Technical Information Service 155/21 ENU WMLO

WMLO - Retrofitting Loudspeaker Booster (Stop Delivery)

Revision: This bulletin replaces bulletin Group 9 155/21 WML0 (982), dated November 29, 2022.

Model Line: **718 (982)**

Installation position

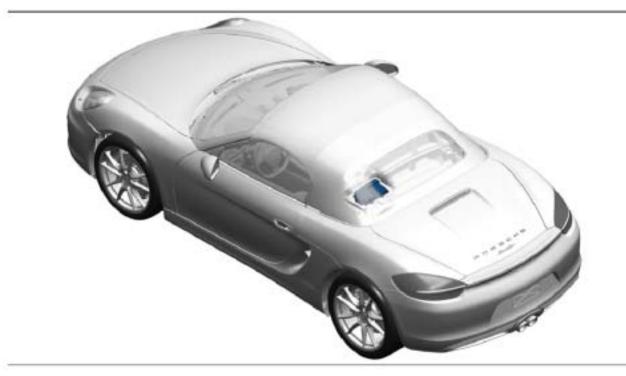
Cause: Due to worldwide semiconductor shortages experienced by some suppliers, the affected

vehicles were built without a loudspeaker booster.

Action required: Retrofit loudspeaker booster.

- (Retrofitting) loudspeaker booster
